MEMO

TO: Ryan Bailey, Village Manager
 FROM: Ryan Amtmann, Village Engineer
 DATE: July 9, 2024
 SUBJECT: Gideon Farms Development

X. The Plan Commission will conduct a second review for proposed annexation and PUD development ("Project") whose approval is being sought by Gideon Farms LLC on property tax keys MRTT0396999006 and MRTT039699902 located at N56W30020 County Road K, Town of Merton. The Plan Commission will review:

Proposed Trail Network
 Village of Hartland - Comprehensive Plan
 Village of Hartland

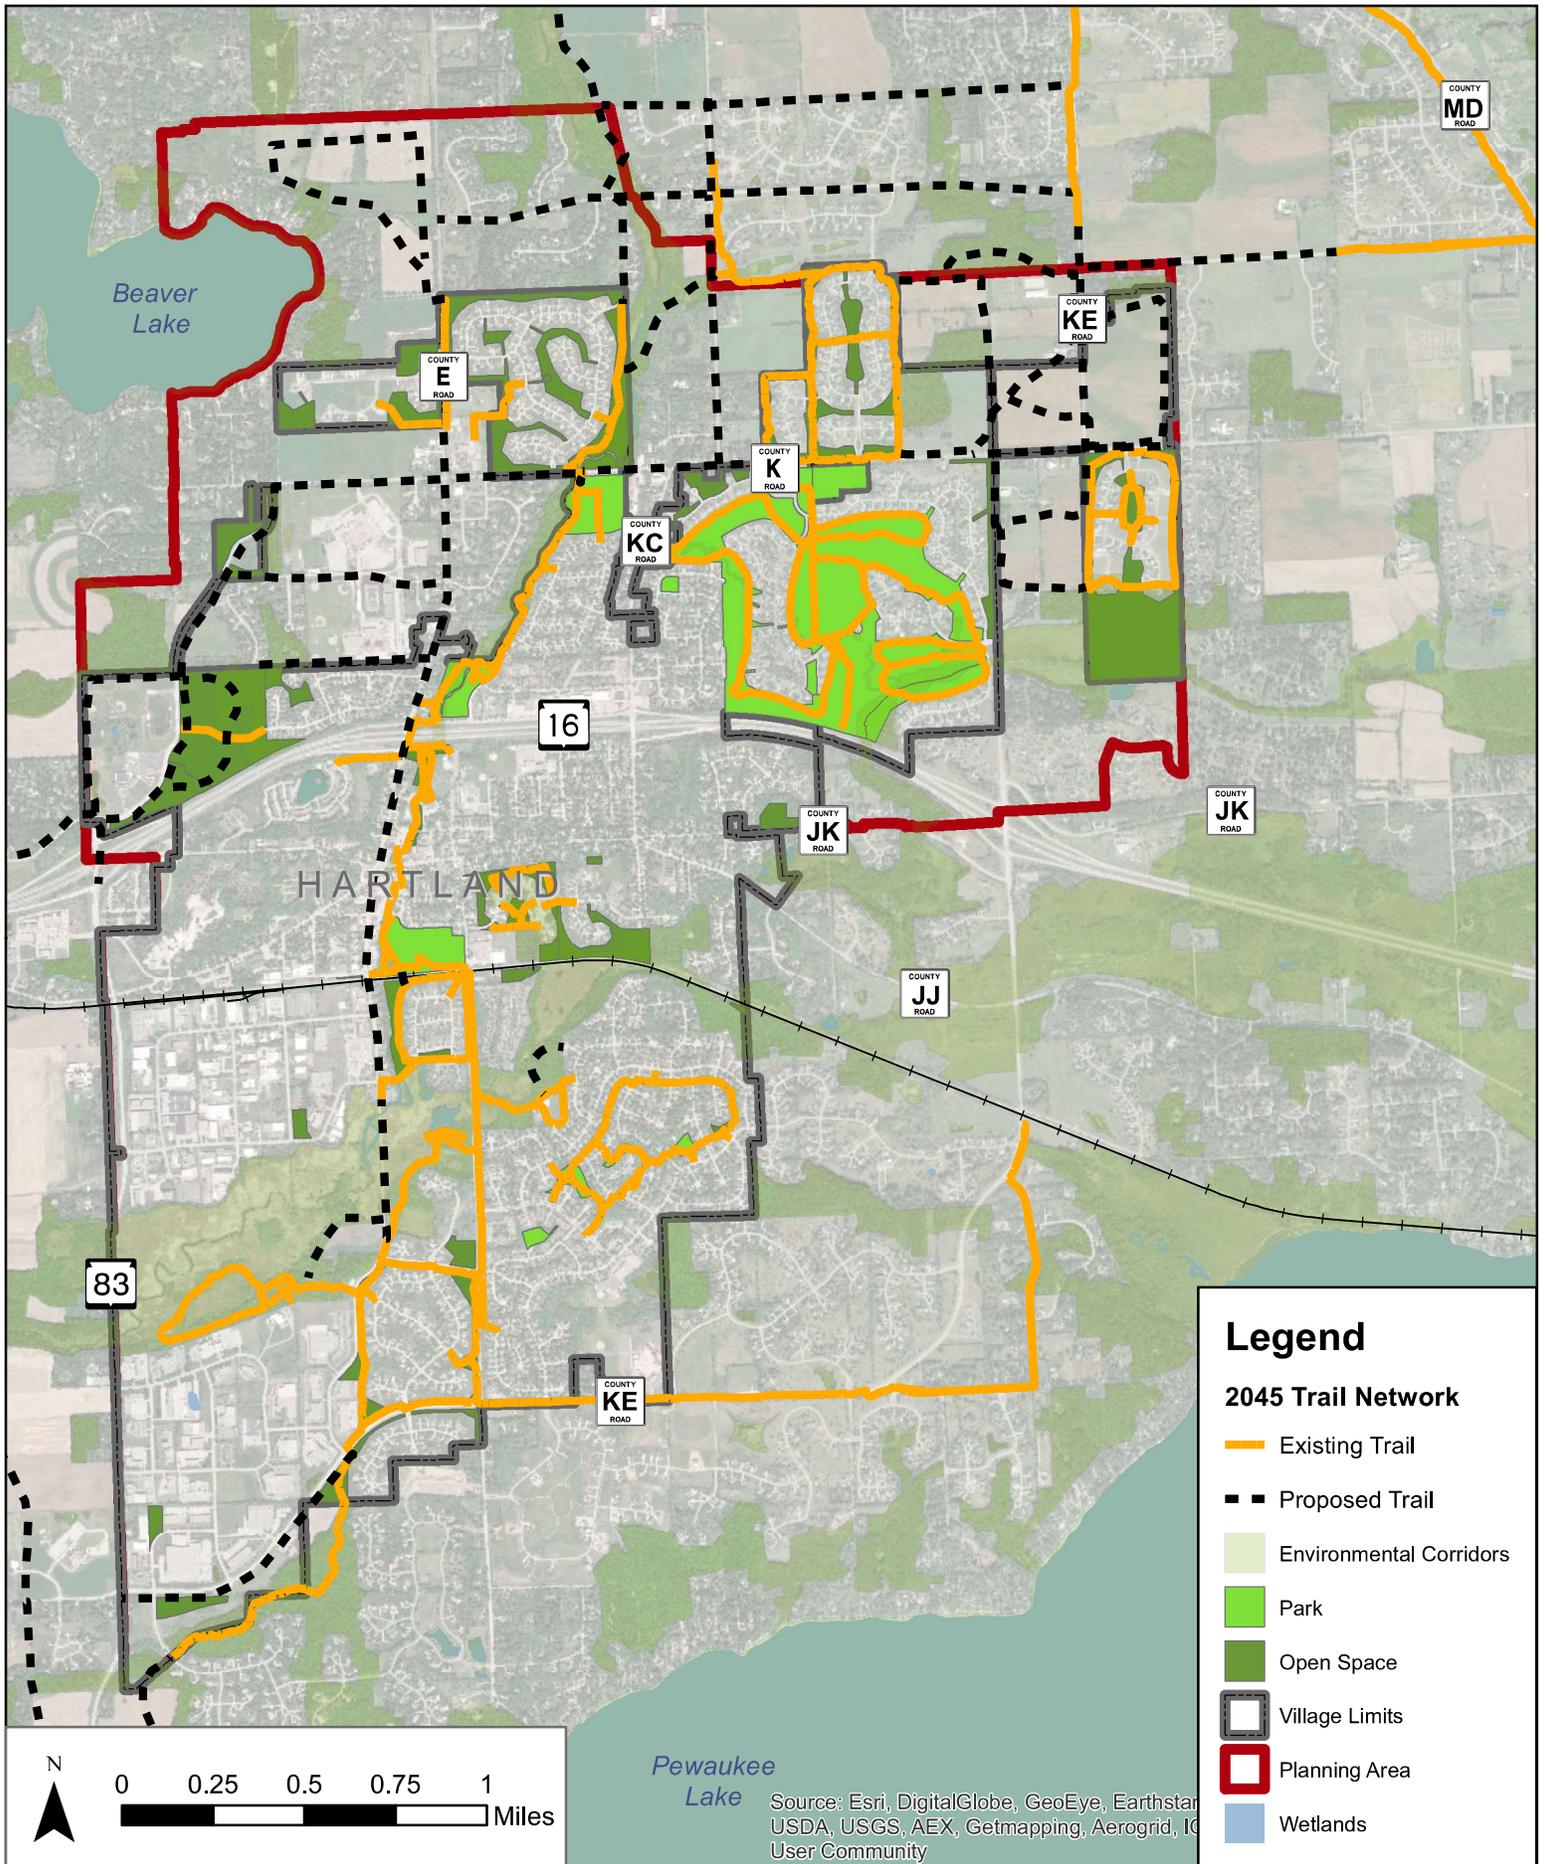
4. Pedestrian/Trail Access –The commercial/retail development aims to attract customers, including pedestrians and cyclists. However, these areas within the Town of Merton along CTH E and CTH K lack adequate pedestrian and bicycle facilities. The Village of Hartland's 2045 Trail Network Map shows plans for connectivity throughout the area. The PUD Agreement presents an opportunity to require the applicant to implement their portion of the trail network, such as paved trails along their parcels that abut CTH K and CTH E. The Village should specify its priorities and potential financial support for the trail network within the project area. Ideally, the existing path from the Four Winds development could be extended westward through Swallow School property to improve connectivity along CTH K, with crossings at CTH E, AHS north driveway and Campus Drive further west along CTH K.
